PUBLIC INTEREST REVIEW FOR GROUND WATER APPLICATIONS

SUBJECT: Application G- 17528 Supersedes review of _____
Date of Review(s)

A. GENERAL INFORMATION: Applicant's Name: Michael Riggs, Rockin R Cattle Co County: Malheur

A1. Applicant(s) seek(s) 1.39 cfs from two well(s) in the Malheur Basin,
Willow Creek subbasin Quad Map: Jamieson

Application G-17528, Michael Riggs, Rockin R Cattle Co. LLC.

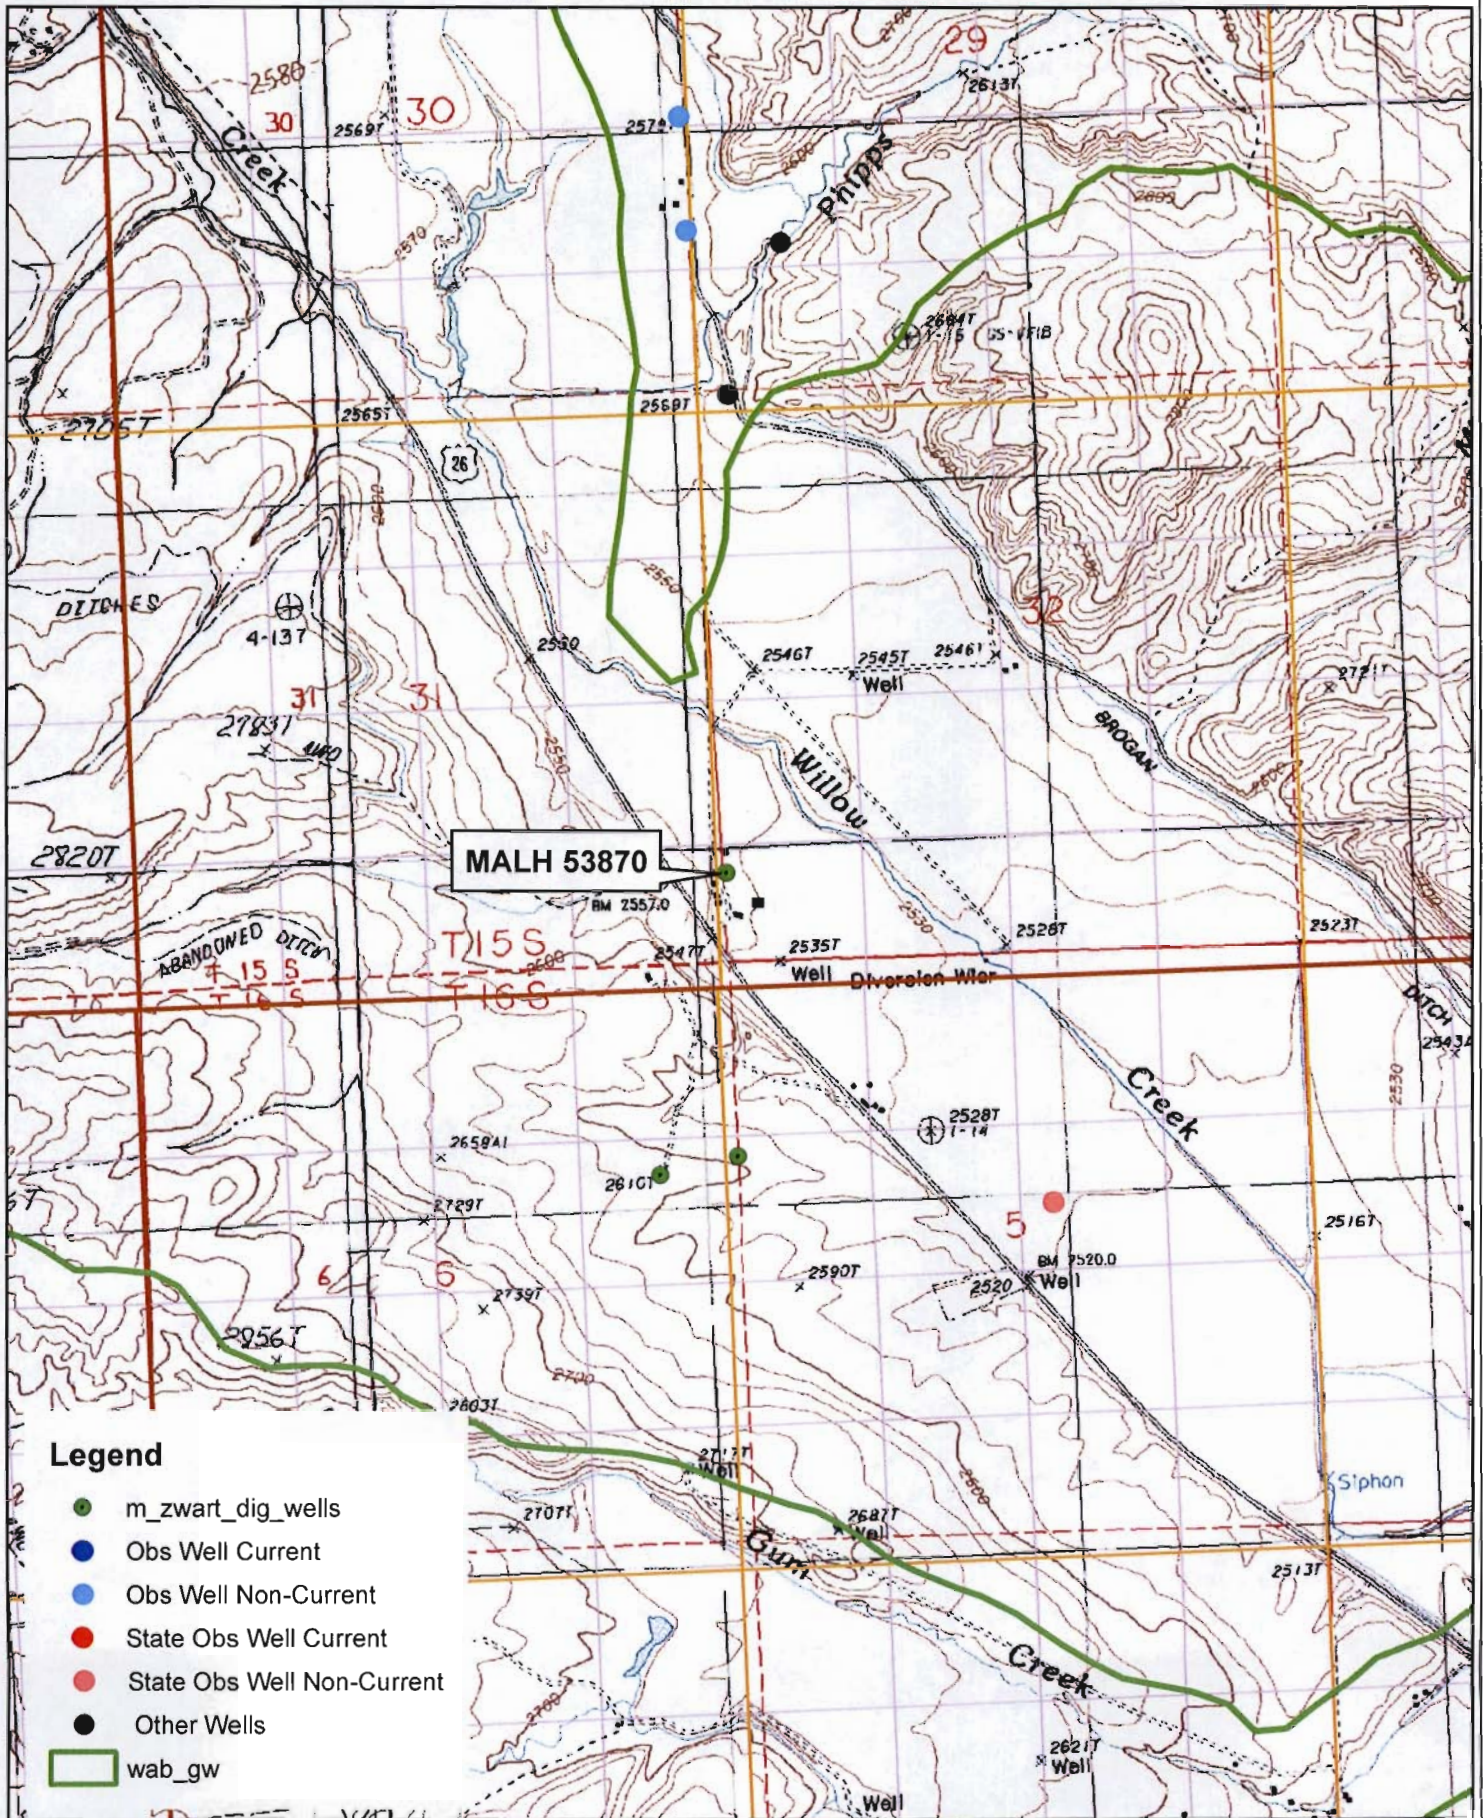
B3. **Ground water availability remarks:** The nearby observation wells (MALH 220 and 122) penetrate an overlying alluvial aquifer, so they are not especially useful to evaluate groundwater availability for the deeper aquifer (Glenns Ferry Formation) penetrated at this well. It appears that there is limited but increasing local development of the deeper aquifer for irrigation in this area.

Basis for aquifer hydraulic connection evaluation: Despite the close head relationship, the aquifer developed likely discharges to the overlying or adjacent alluvial deposits and therefore is in indirect and inefficient hydraulic connection with the nearest reach of the creek.
